**MOORE PUBLIC SCHOOLS -  
HIGHLAND EAST JUNIOR HIGH SCHOOL  
STEM ADDITION**

-----  
**ADDENDUM NO. 1**

January 26, 2022  
-----

**ADDENDUM No. 1**

**2**  
ELEVATION @ TYP. LAB  
1/4" = 1'-0"

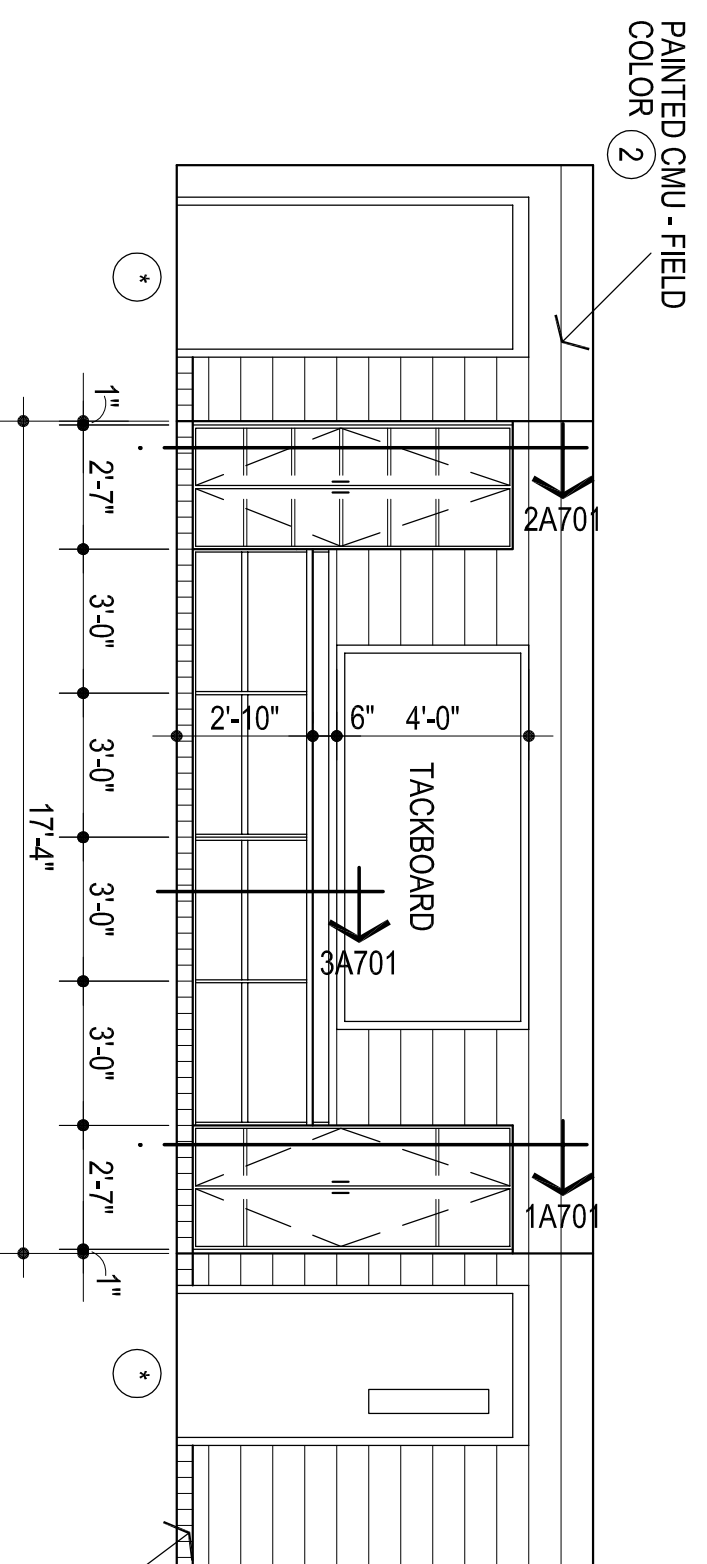
1. Sheet A103, Detail #1, Floor Plan: revise interior elevation referencing in Rooms #17, 22, and 26 as per attached revised drawing.
2. Sheet A401, Detail #2, Elevation at Typical Lab: revised number of equal spaces for shelving to "7 spaces" in lieu of six as indicated. Refer to attachment.
3. Sheet A501, Detail #20, Plan Detail and Sheet 601, Detail #2, Color Schedule: refer to attached Request for Information #2 for clarifications.
